MISSOULA COUNTY

BCC 2018-077
March 28, 2018

Re: Draft HHRA OU2 and OU3, BERA OU2 and OU3

1978 photo showing buried drum

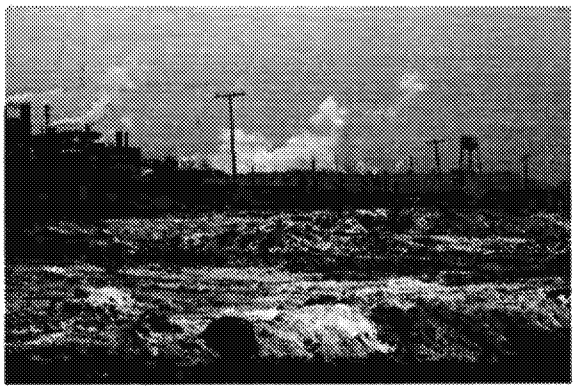
Photos from DEQ files and photos provided by past workers show that drums were buried in these dumps in 1978 and 1992. This has not yet been evaluated.

1992 DEQ file photo, showing waste buried in groundwater

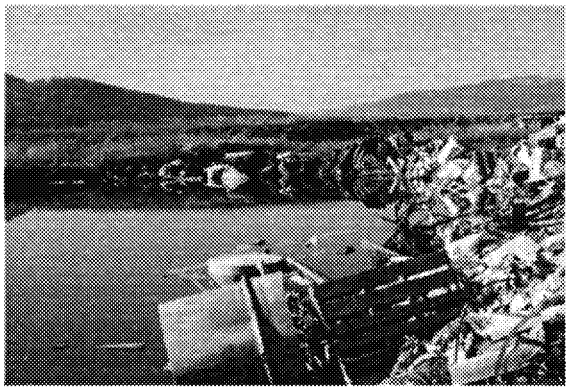
A large flood has the potential to erode 53 years of accumulation of sludge, ash and industrial waste that has yet to be properly characterized. These photos are evidence of the materials that may be currently affecting groundwater and are certainly vulnerable to floods.
